IN RE: PETITION SPECIAL EXCEPTION *
 S/S of Relocated Milford Mill *
 Road, 750' SW of Reisterstown *
 Road - 3rd Election District *
 Linden Terrace Partnership, *
 Petitioner *
 Case No. 86-297-X

FINDINGS OF FACT AND CONCLUSIONS OF LAW

Arnold Jablon
TO: Zoning Commissioner
Norman E. Gerber, AICP, Director
FROM: Office of Planning and Zoning
SUBJECT: Zoning Petition No. 86-297-X

PROJECT NAME: LINDEN TERRACE PLAN XXXXXXXXXXXXXXXX
COUNCIL & ELECTION DISTRICT III-290 PLAN EXTENSION
REVISED PLAN
PLAT

CRG LANDSCAPE PLAN

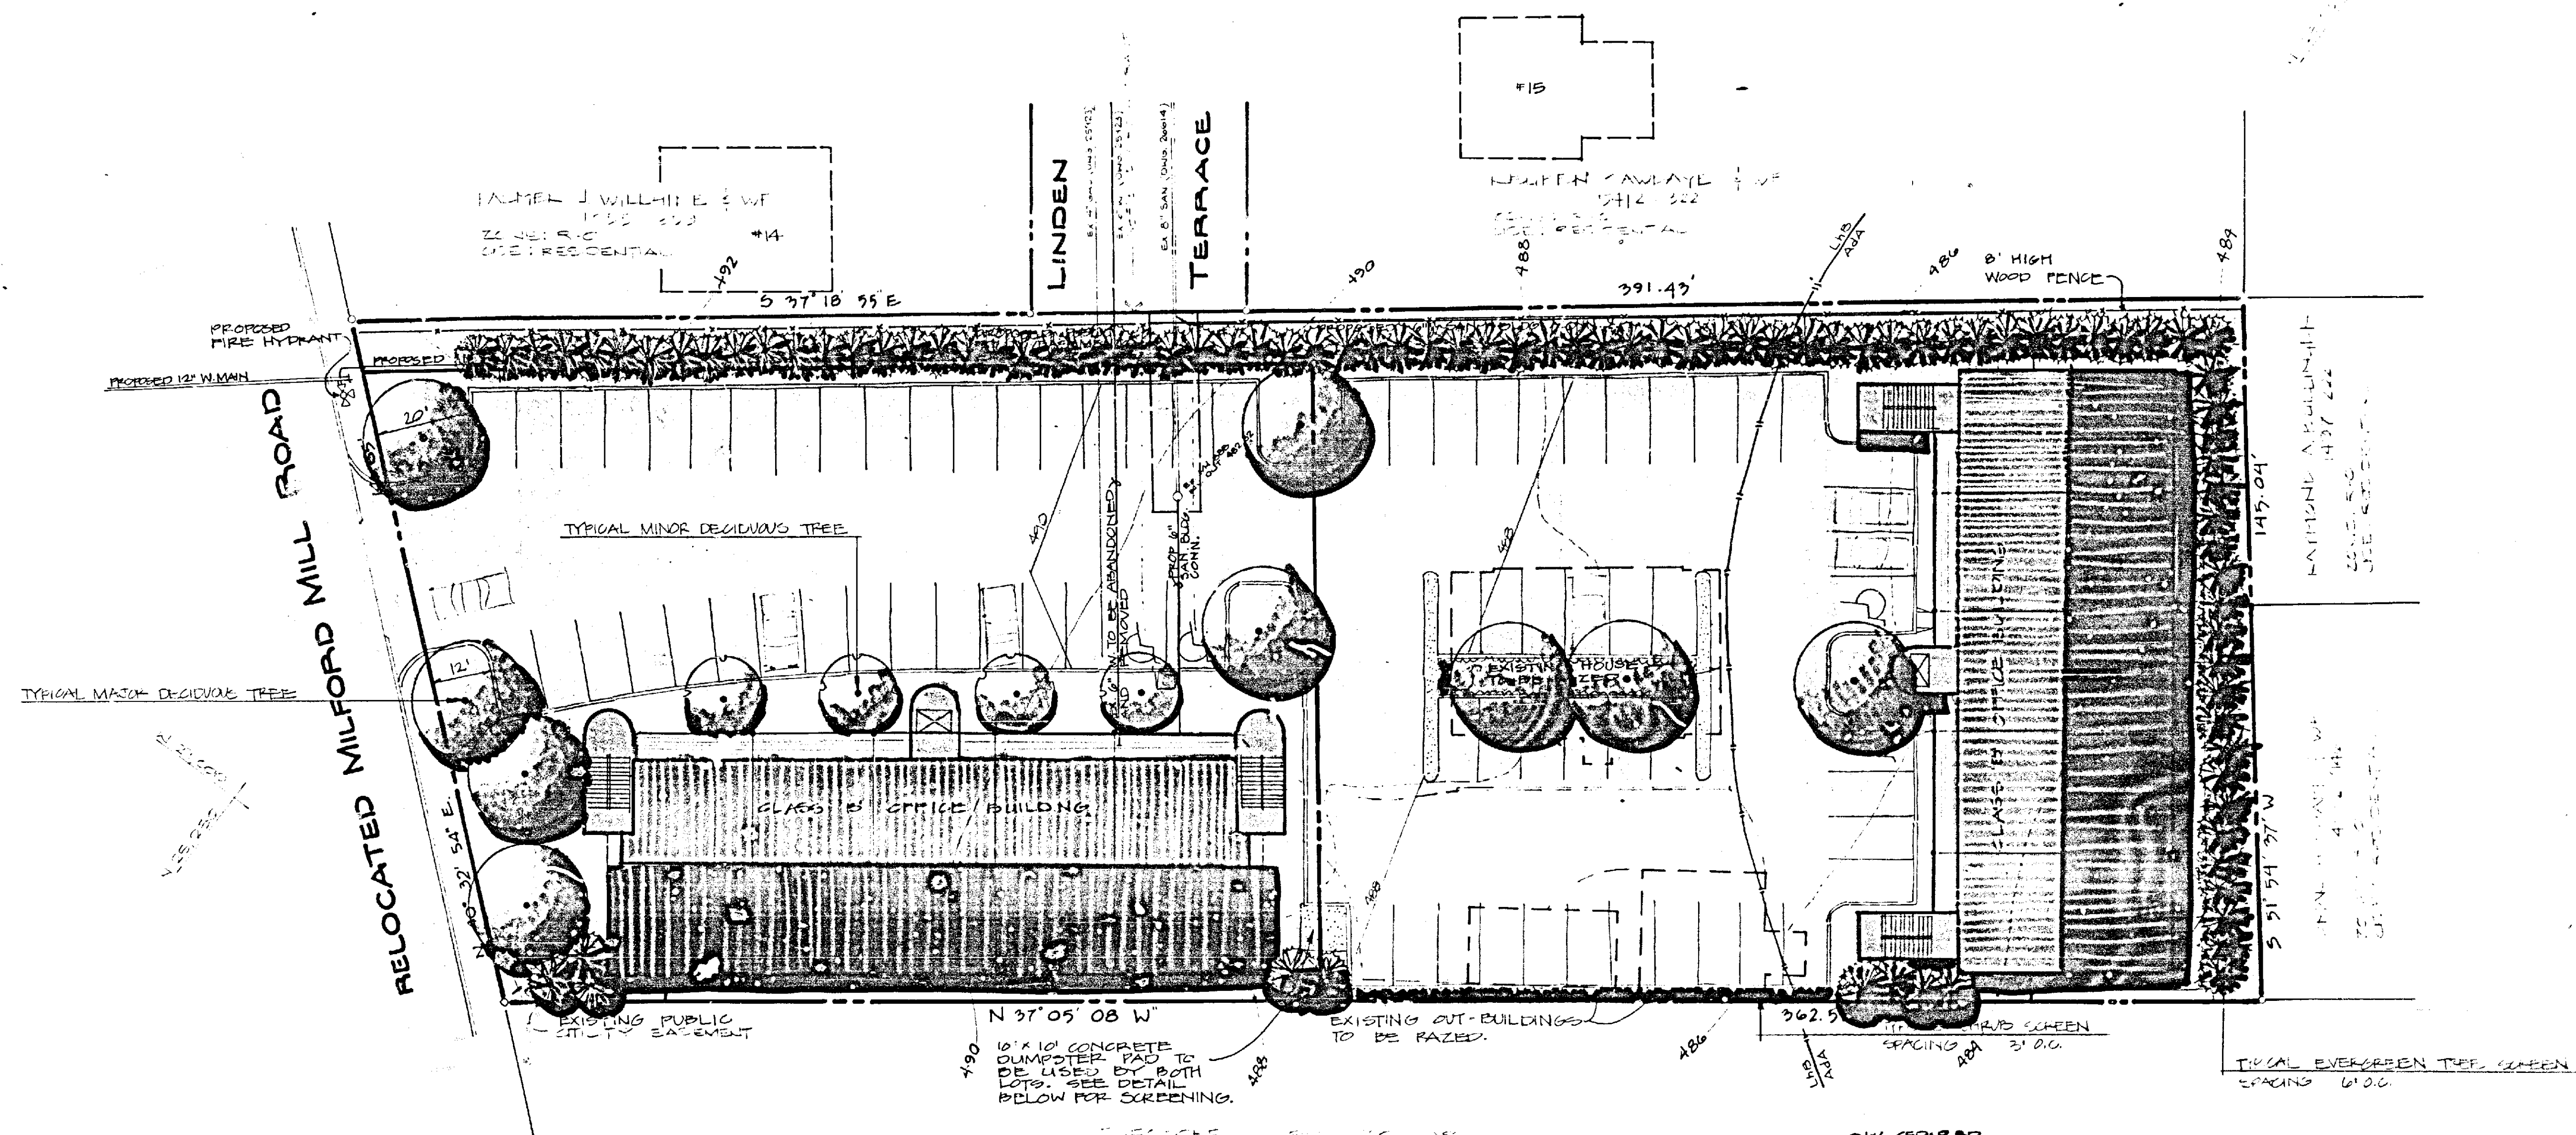
The proposed 5' high screen planting along the northeast and eastern property lines does not appear to provide an adequate buffer between the office buildings and adjacent residences. In an effort to enhance this buffer, consideration should be given to screening by means of attractive wooden fence with large trees. In addition, the relocation of the parking further away from the Willhide and Sawdaye properties should be considered. This shift of the parking area will increase the distance between the development and the houses and may allow the retention of some existing large trees on this site.

FLOOR PLAN - 1ST LEVEL - OFFICE BUILDING LOT N-1
DATE: 1/8/86

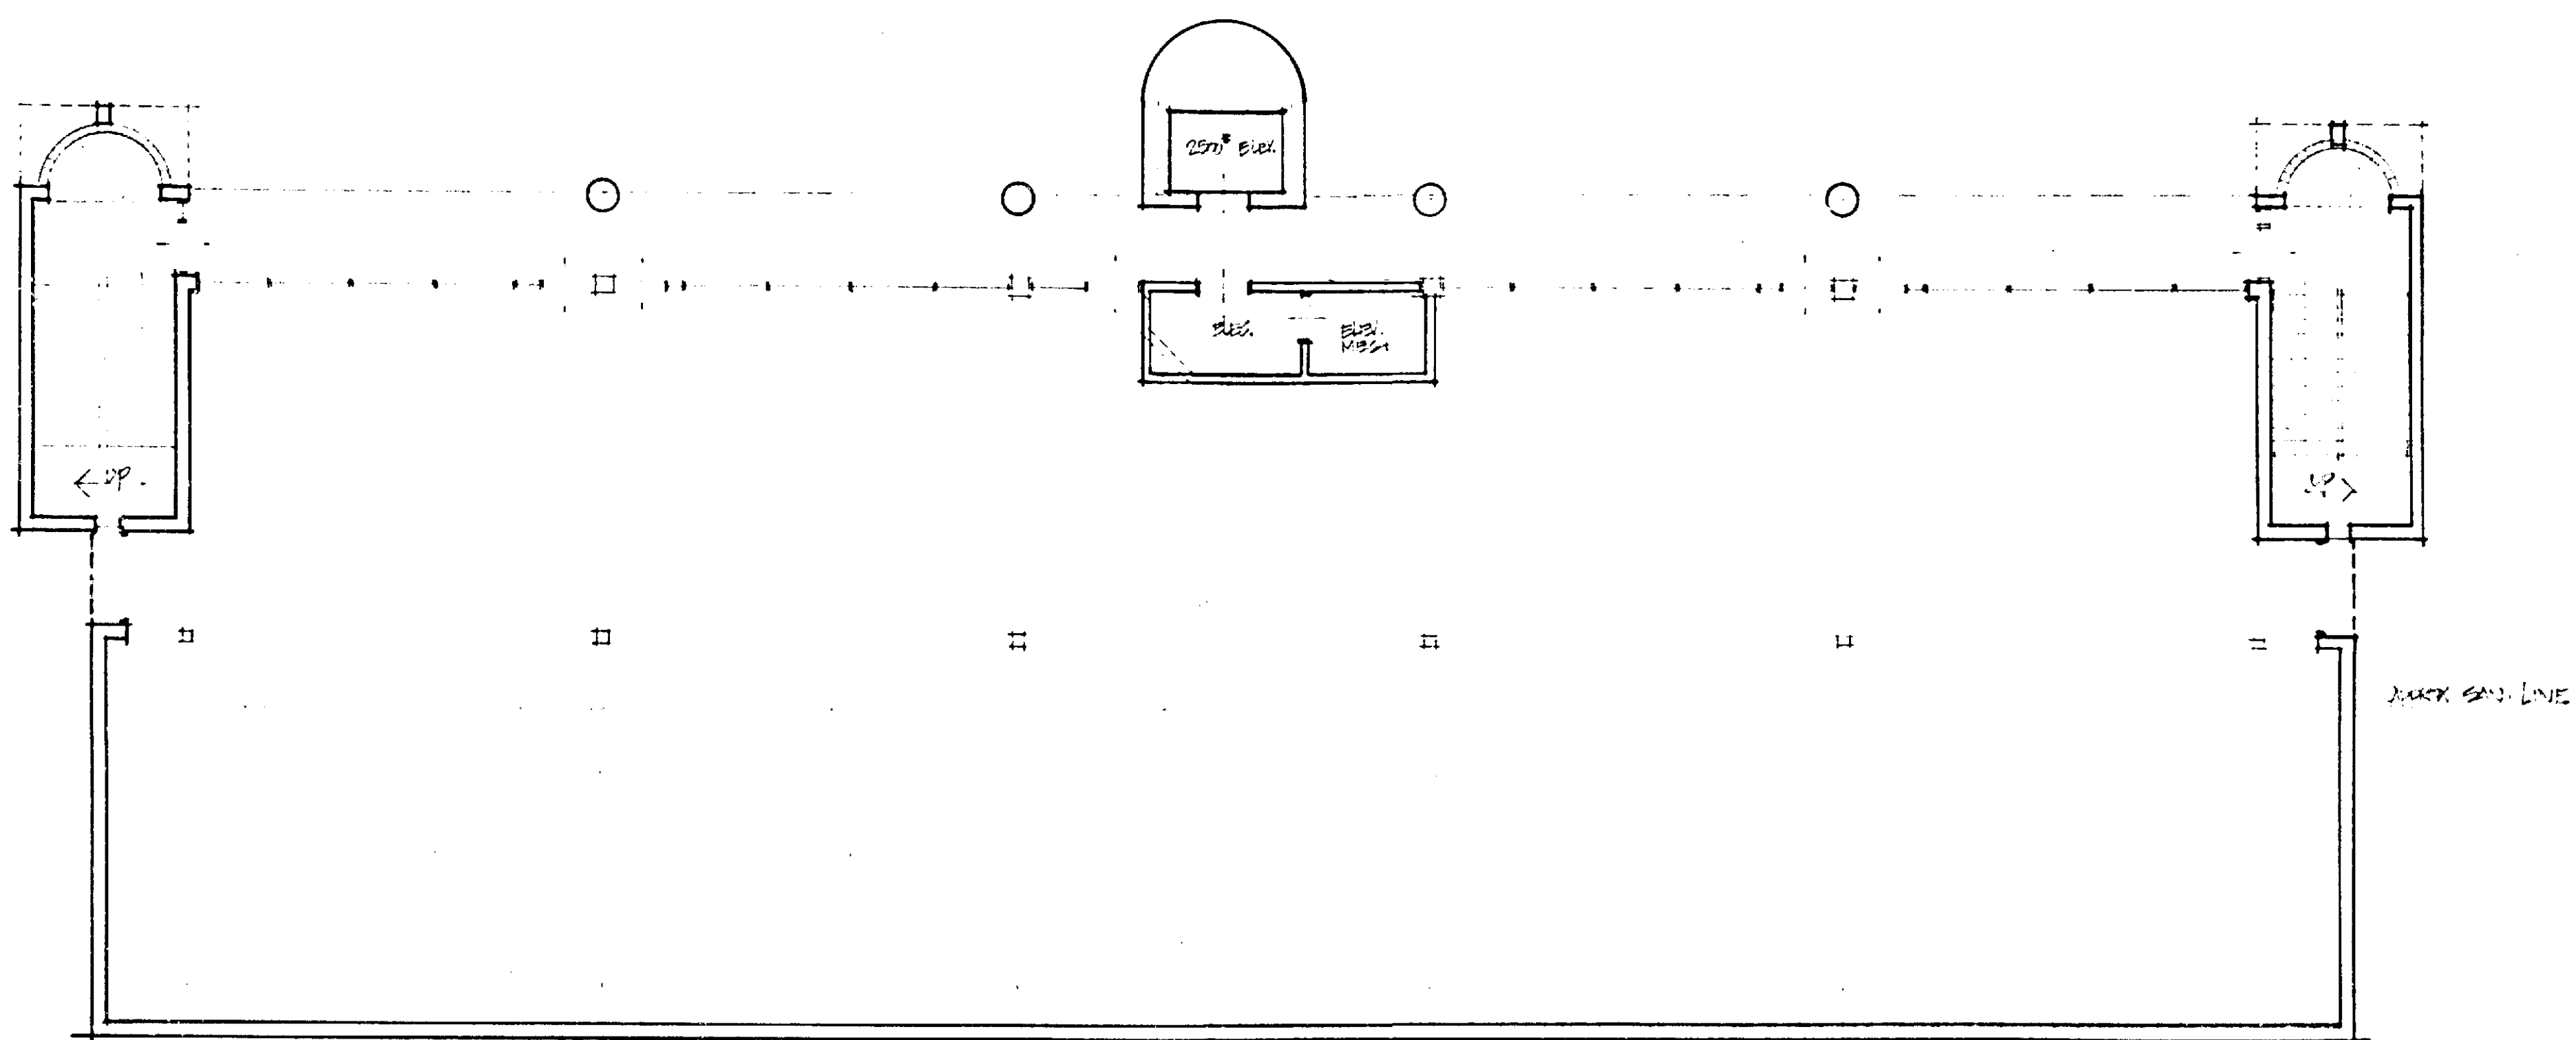
- Lot #1, windows and doors on the south side could be in a firewall and require rated opening protectives due to the 0'-0" setback division line. See Section 101.1. The same is true of setbacks less than 15'-0" on Lot #2.
- Two handicapped places shall be provided for each independent structure, for a total of 4. Only two are shown.
- Property division line shall provide exit access and discharge width of not less than 44" between it and building in case either property is later sold.
- An 18'-0" fire lane shall be provided to Lot #2 if Section 502.3 is used in height and area.
